TENDER 7119-KP-21 - Addendum #4

Project: Elmira District S.S. - Window, Roof, HVAC & Sanitary Upgrades

Project Name:	Elmira District Secondary School – Window, Roof, HVAC and Sanitary Upgrades	Date Issued:	March 25, 2021
Quasar Project #:	ED-20-300		
Client Project #:	20931		
Addendum #: M-1 Revision #: 0

Project Name:	Elmira District Secondary School – Window, Roof, HVAC and Sanitary Upgrades	Date Issued:	March 25, 2021
Quasar Project #:	ED-20-300		
Client Project #:	20931		
Addendum #: E-1 Revision #: 0

DRAWING TITLE: HVAC - CAFETERIA ROOF - DEMO AND NEW WORK PLAN
	PROJECT NO:ED-20-300PROJECT NORTH:SCALE:AS SHOWNImage: Constraint of the second
	drawing no: M-102

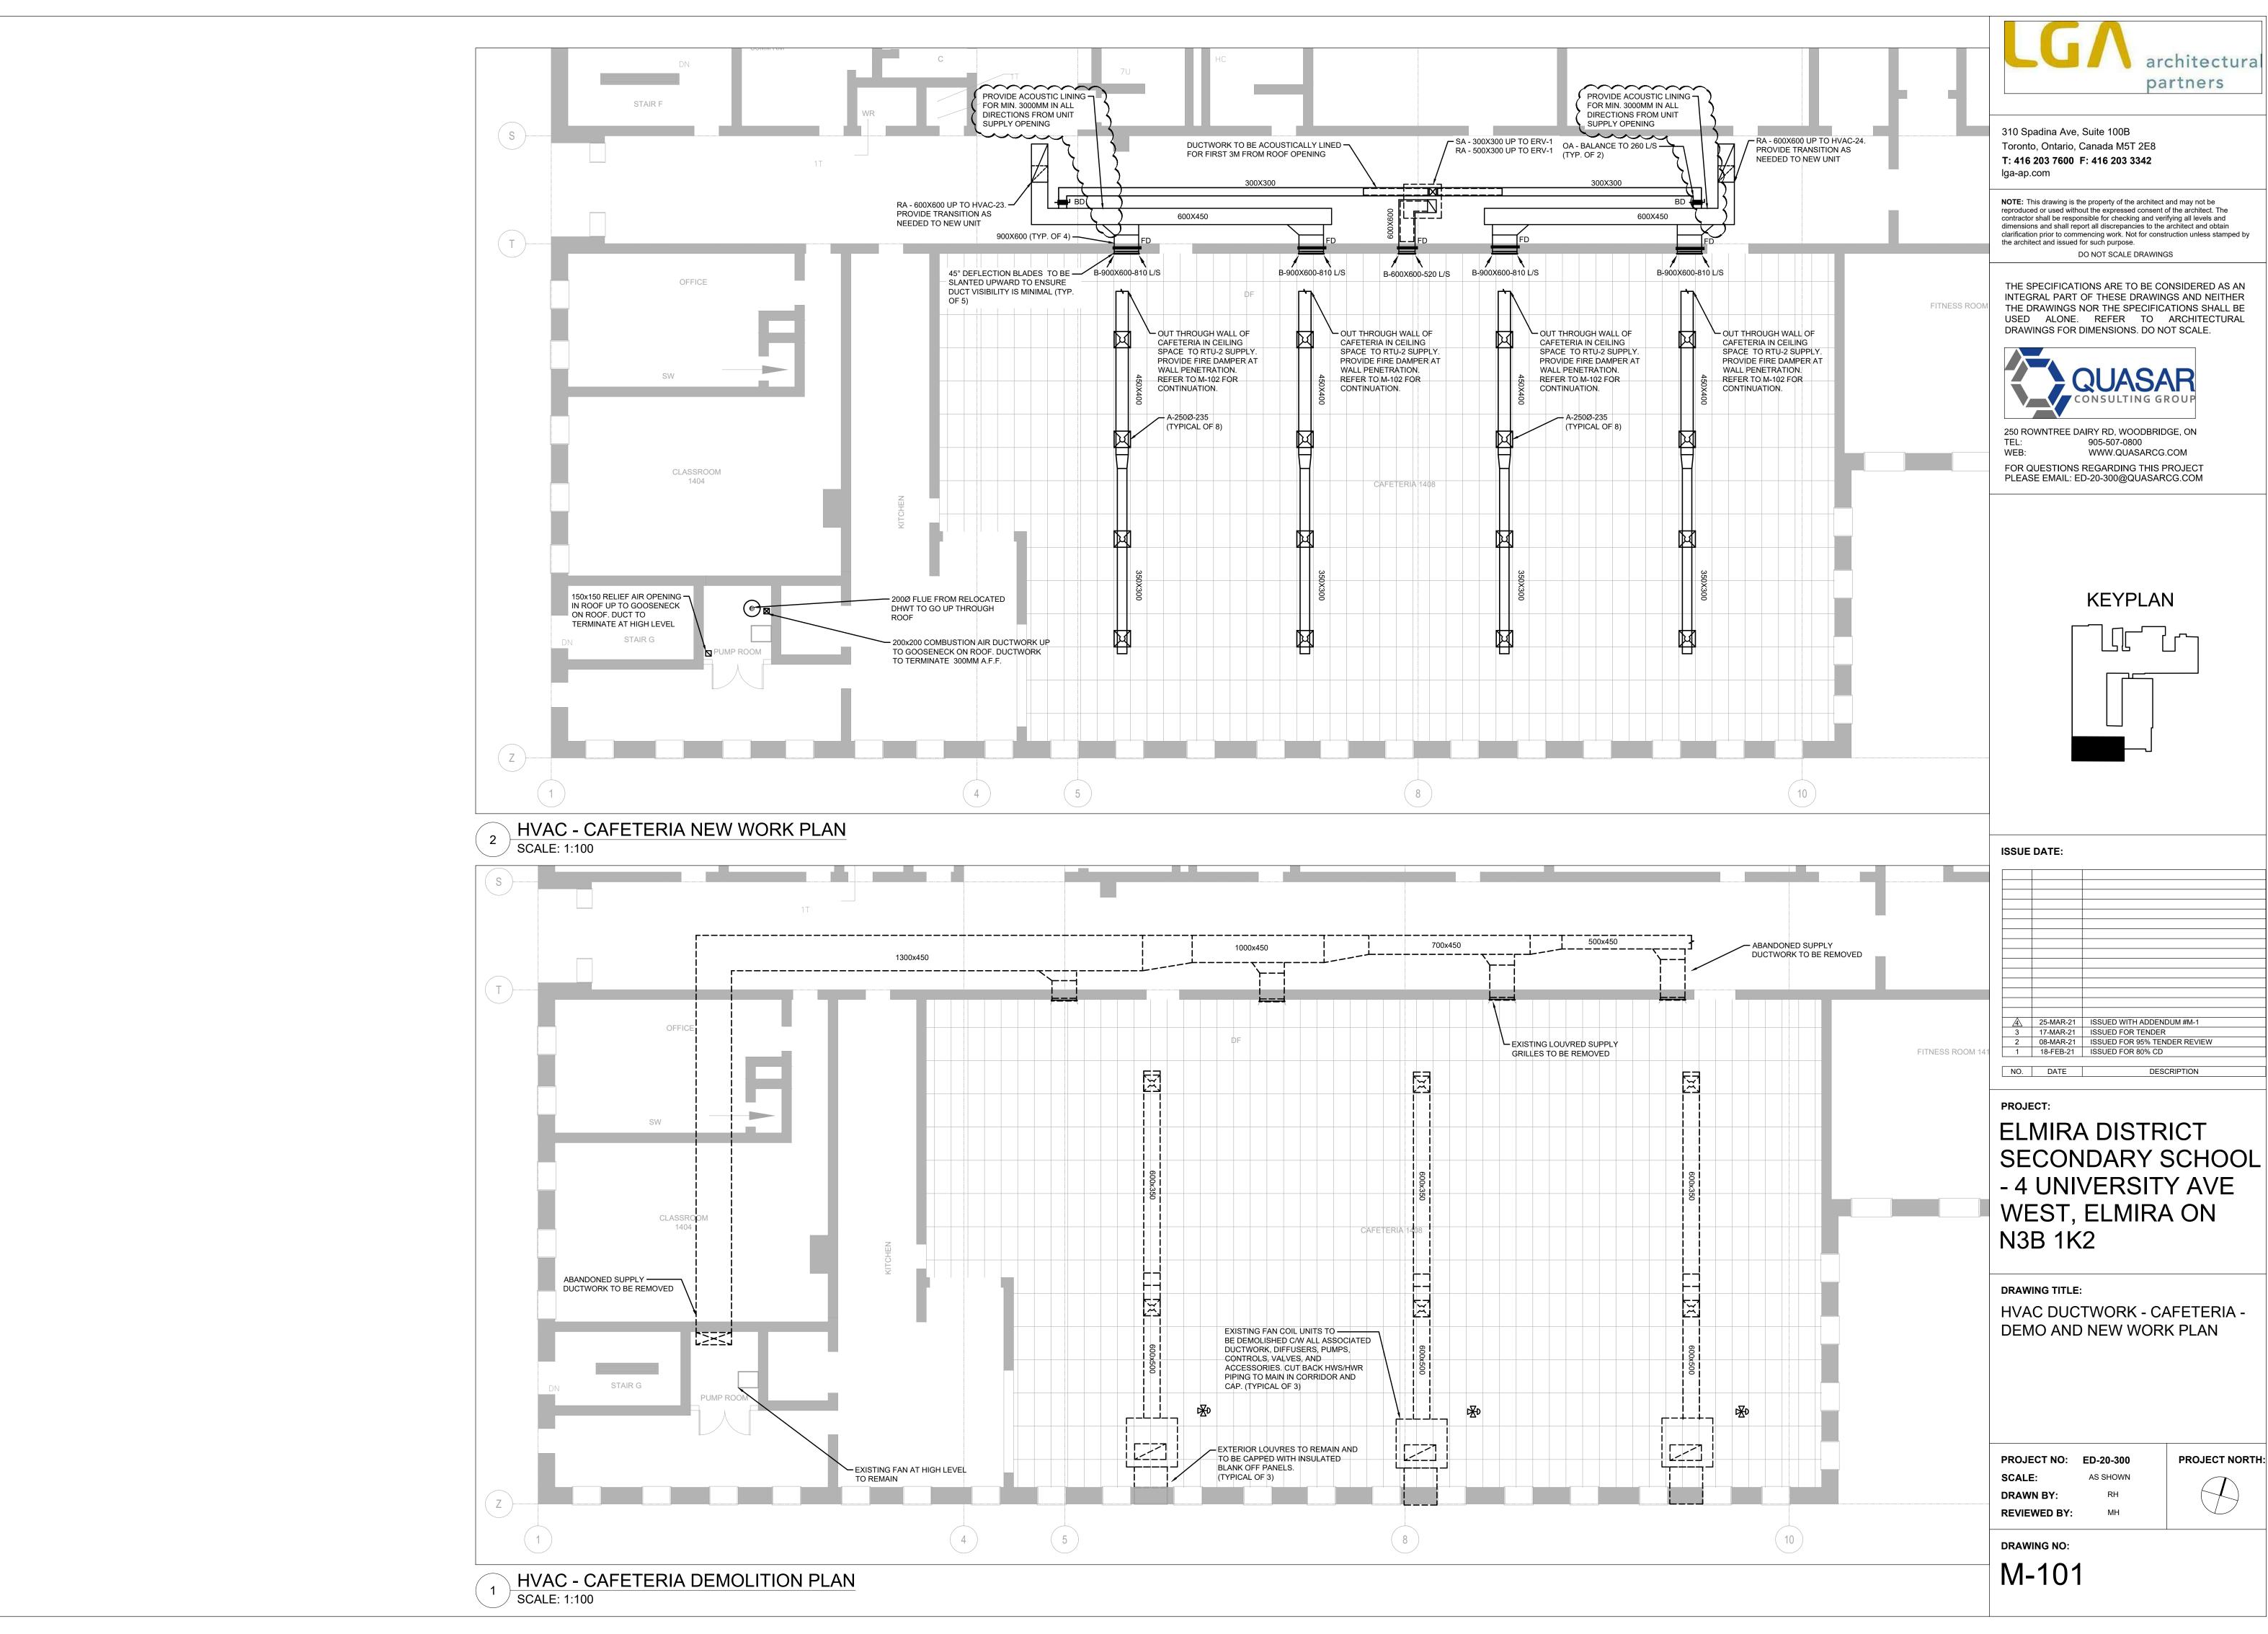
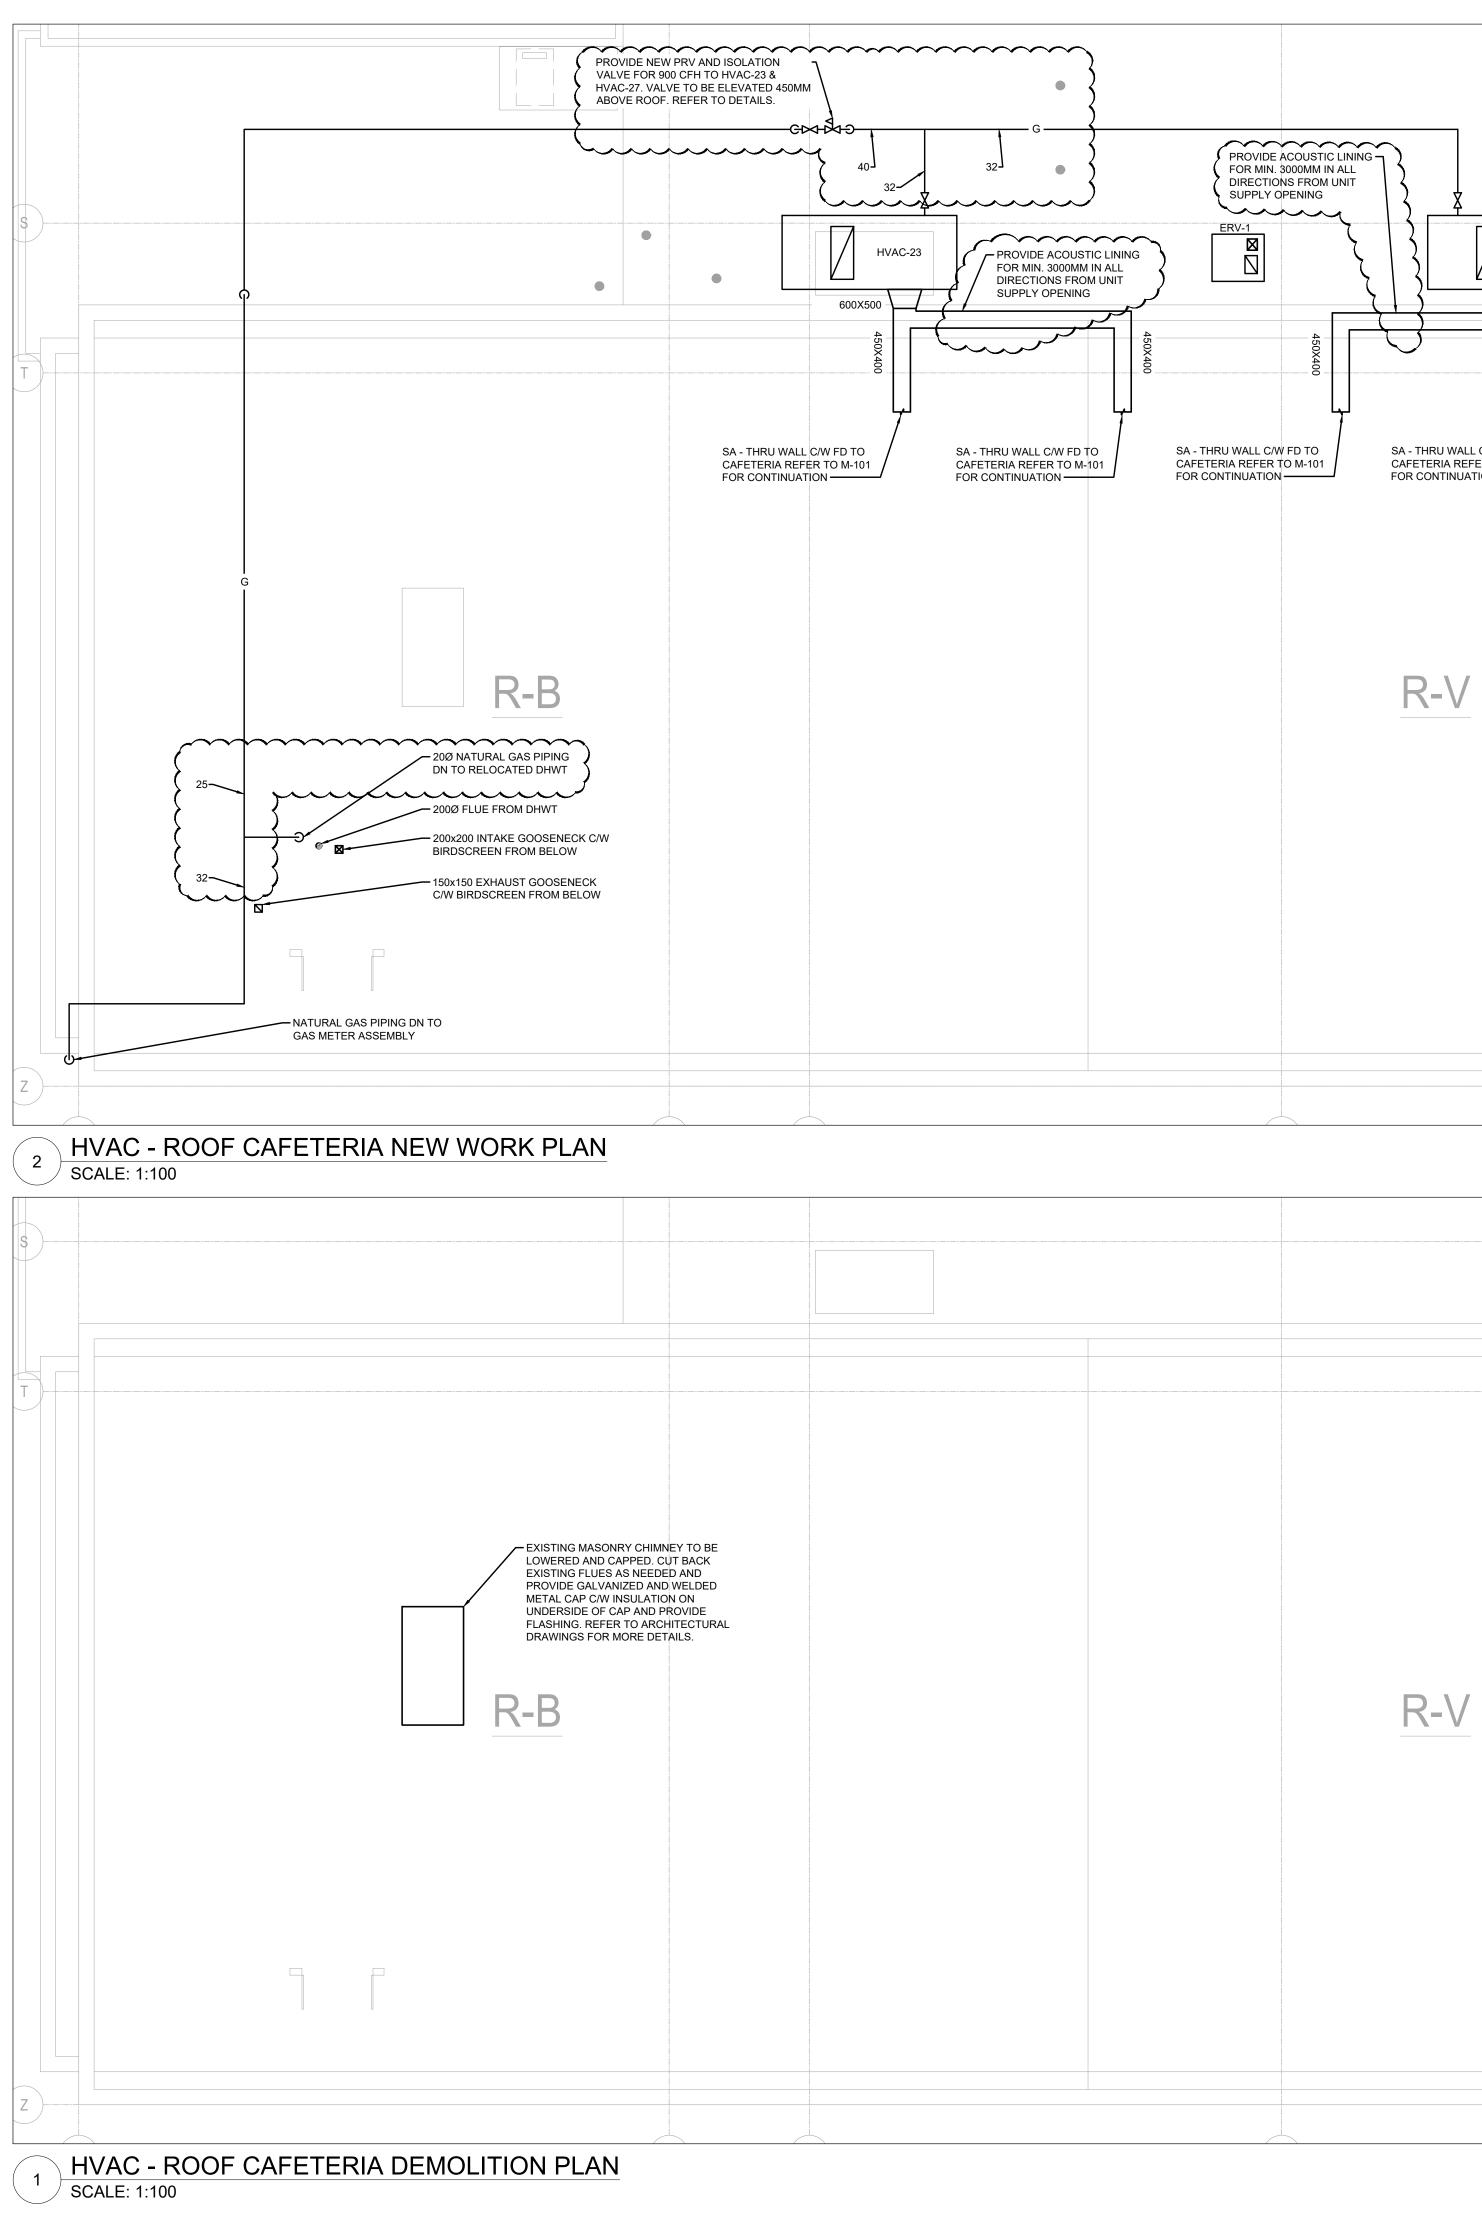
3. DRAWING M-102 - HVAC- CAFETERIA ROOF - DEMO AND NEW WORK PLAN

- a. Revised natural gas pipe sizing as shown;
- b. Addition of acoustic lining in supply ductwork as shown.

DRAWING TITLE: HVAC PIPING - CAFETERIA - DEMO AND NEW WORK PLAN
PROJECT NO: ED-20-300 PROJECT NORTH: SCALE: AS SHOWN Image: Comparison of the second se
drawing no: M-103

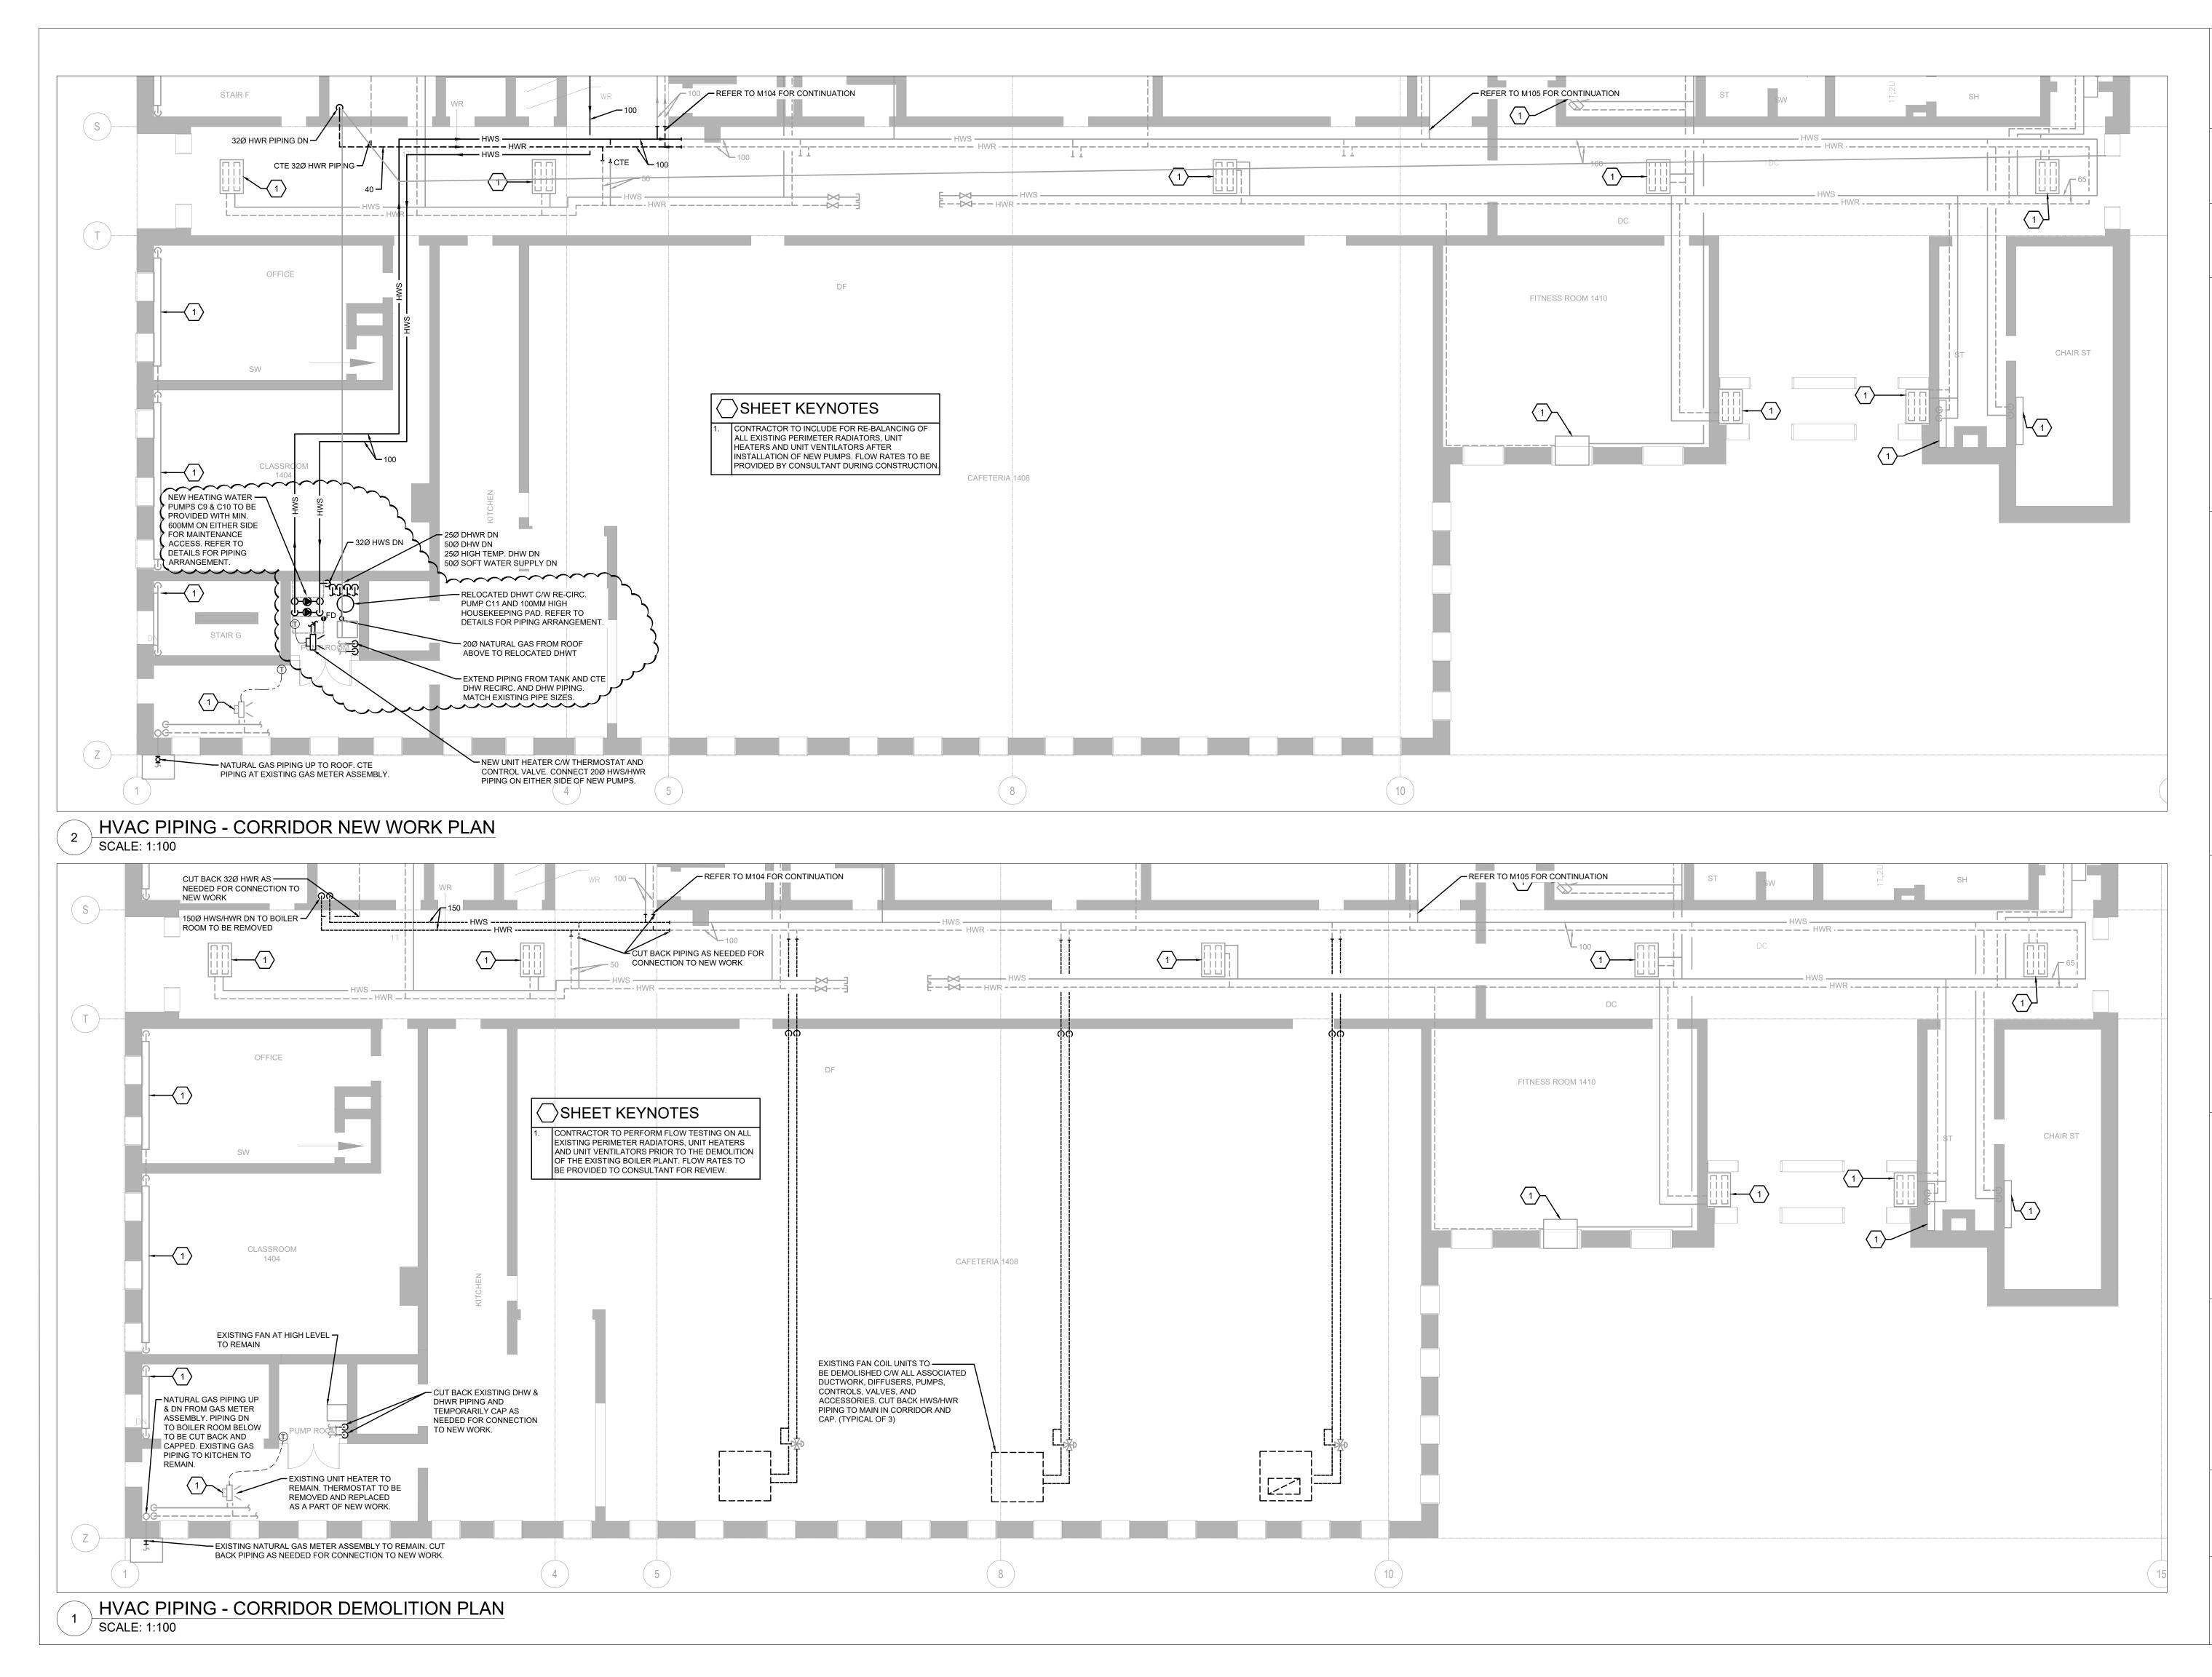
4. DRAWING M-103 – HVAC PIPING – CAFETERIA - DEMO AND NEW WORK PLAN

a. Revised pump room layout as shown.
